CONSTRUCTION – PHASE 2

**NEW CENTER FOR EMERGENCY SERVICES  
25 ROCKY HOLLOW ROAD  
NORTH STONINGTON, CT 06359**

S/P+A PROJECT NO. 13.220

**DATE: February 23, 2017**

TOWN OF NORTH STONINGTON		NEW CENTER FOR EMERGENCY SERVICES TOWER FOUNDATION		25 ROCKY HOLLOW ROAD NORTH STONINGTON, CONNECTICUT 06359	
DATE:	02/08/2017	SCALE:	As indicated	JOB NO.	17021.00
SCHEMATIC AND NOTES					
ESK-1					
Sheet No. 2 of 2

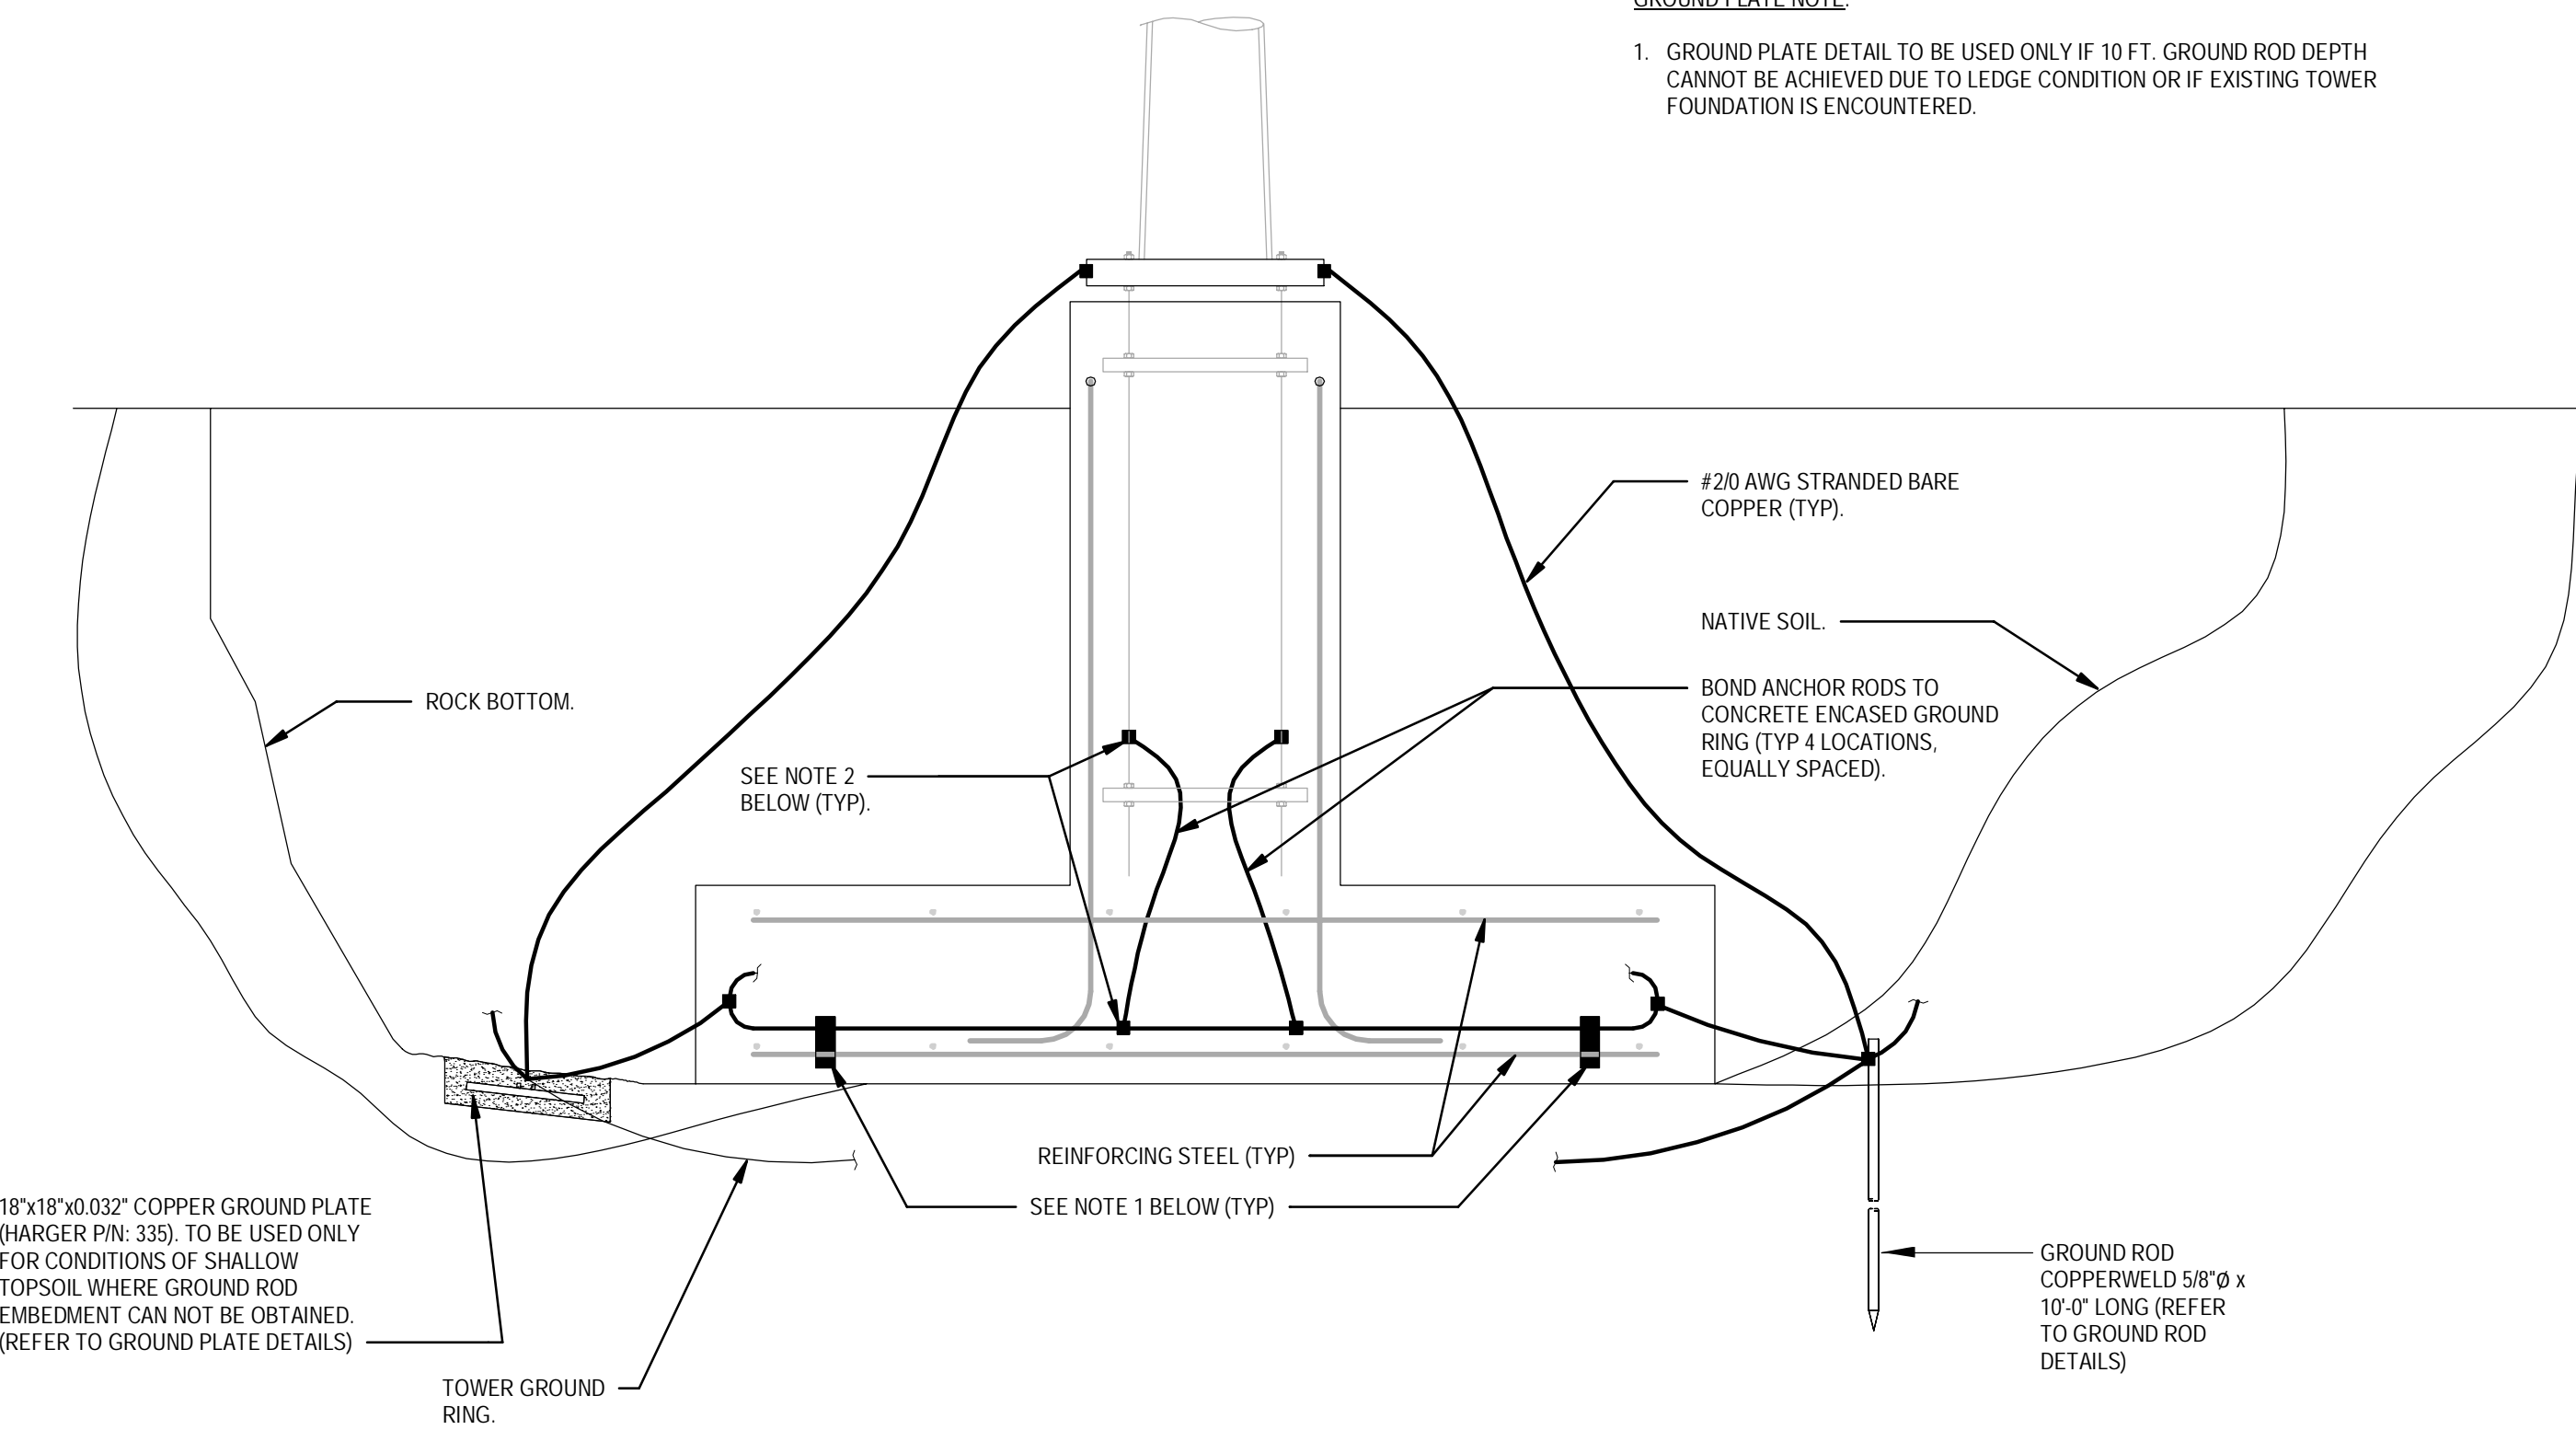
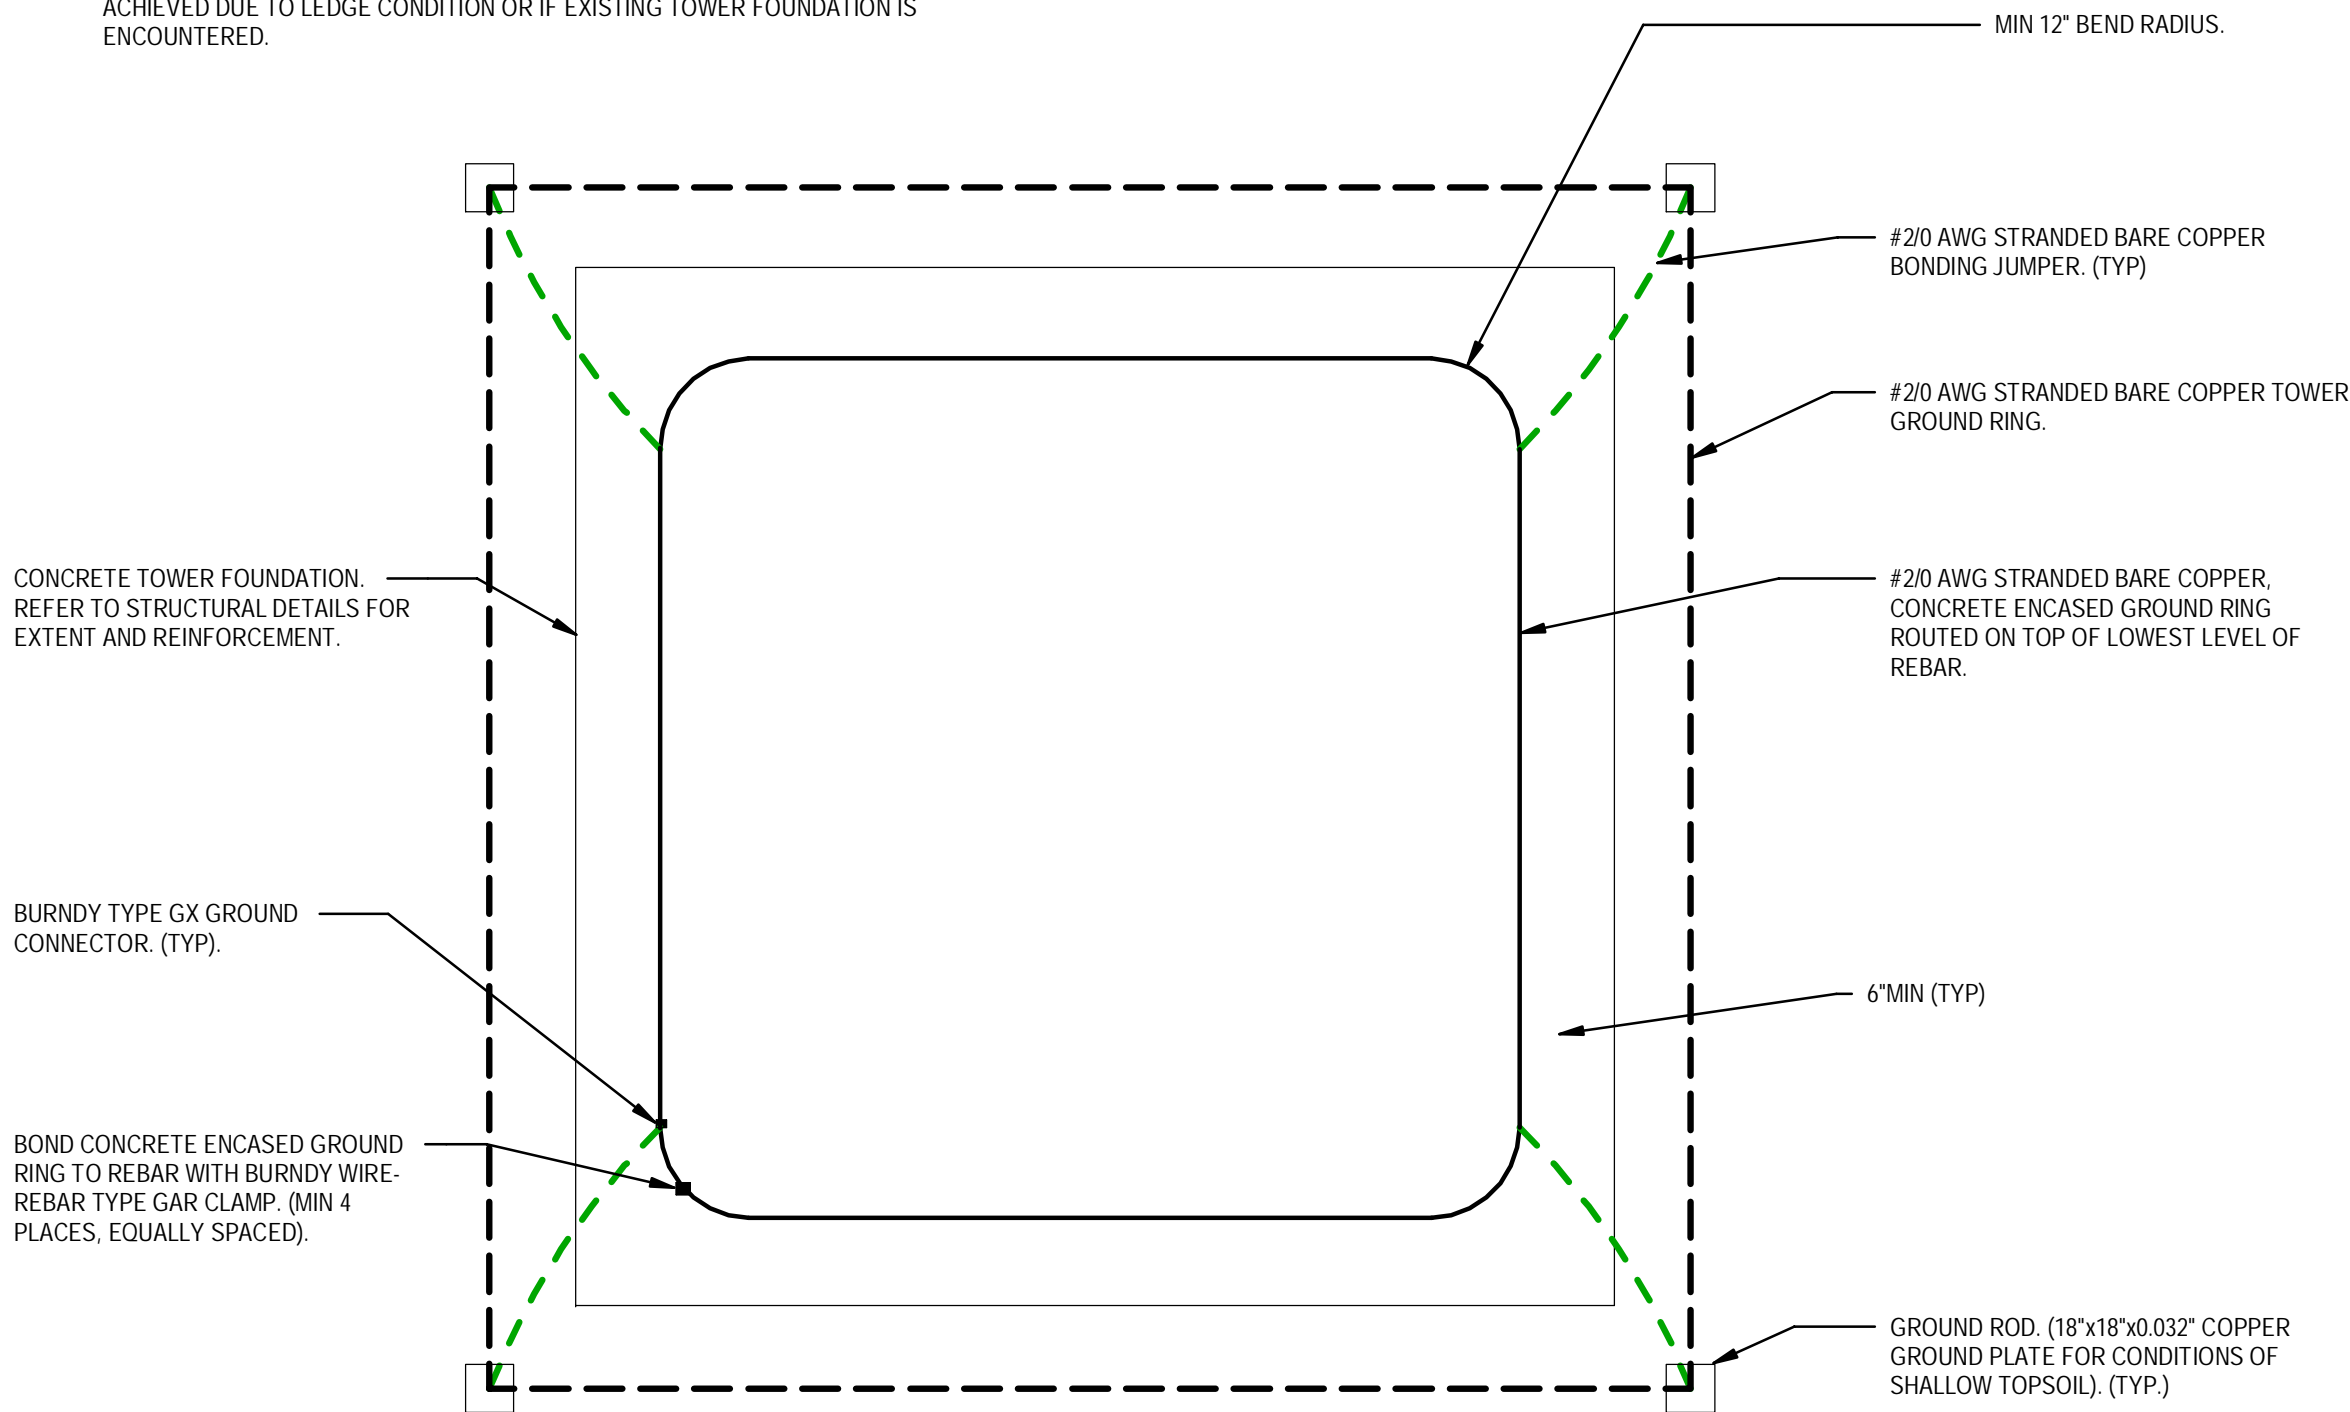
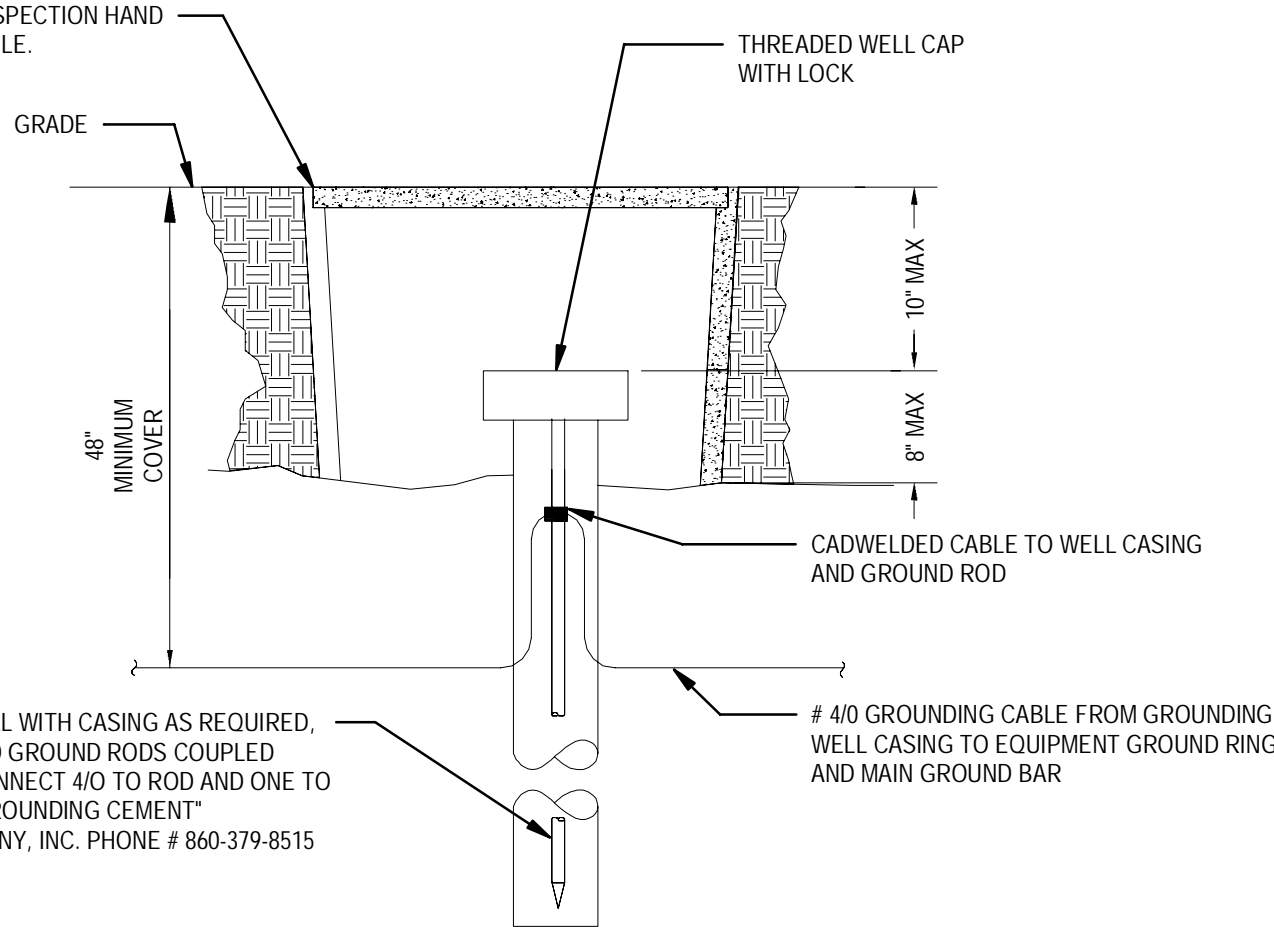
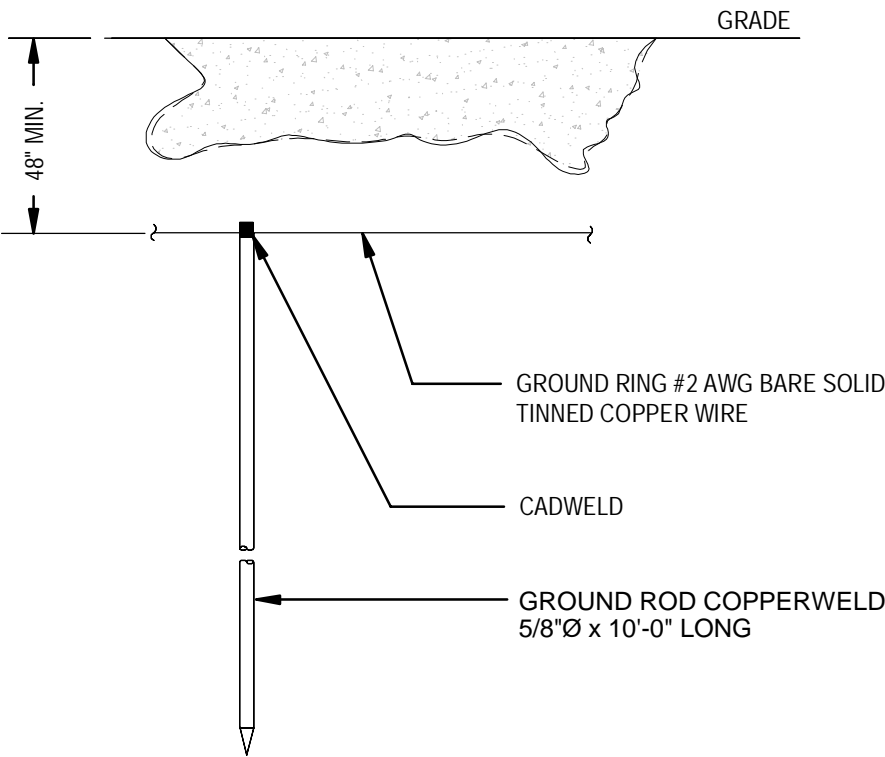
- The following CIVIL drawings (2) have been added and are attached as part of this addendum.^
  - SSK-1, FOUNDATION & DETAILS (TOWER)
  - ESK-1, SCHEMATIC & NOTES (TOWER)
- The following ARCHITECTURAL sketches (2) have been added and are attached as part of this addendum.
  - SKA1A, ADDENDUM #1 – DETAIL AT STONE BASE. This sketch revises Detail B on Drawing A9.0.
  - SKA1B, ADDENDUM #1 – STONE BASE DTL – END WALL. This sketch revises Detail C on Drawing A9.0.
